ANN ARBOR HISTORIC DISTRICT COMMISSION**Staff Report****ADDRESS:** 1021 W Huron Street, Application Number HDC20-096**DISTRICT:** Old West Side Historic District**REPORT DATE:** August 9, 2020**REPORT PREPARED BY:** Jill Thacher, Historic Preservation Coordinator**REVIEW COMMITTEE DATE:** August 6, 2020**OWNER****APPLICANT**

APPLICATION: The applicant seeks HDC approval to modify the roofline of an existing garage, install three windows in a boarded garage bay, and install new fiber-cement siding and boral trim.

1931 Sanborn

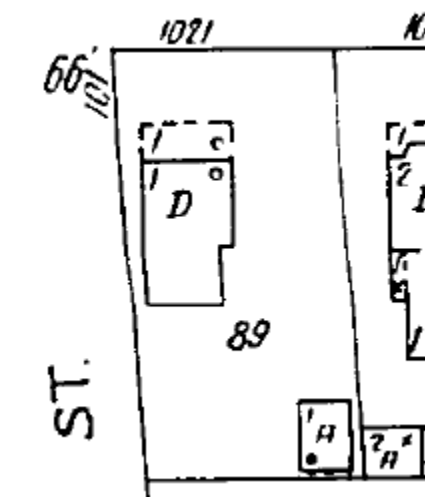
1. The garage at 1021 W Huron first appears on Sanborn Fire Insurance Maps in 1925, with a smaller footprint and east/west orientation. In 1931 it is shown as a north/south rectangle in the rear corner of the lot, and likely sharing the driveway with the house to the east. The 1947 aerial confirms that there is no driveway off Ninth Street, though the building now looks square. Permits were issued to tear the house to the east down in 1965 and a large apartment building replaced it next door. It is believed that 1021's driveway was moved to Ninth Street at that time, and the front of the garage could have been moved to face the new drive to the west.
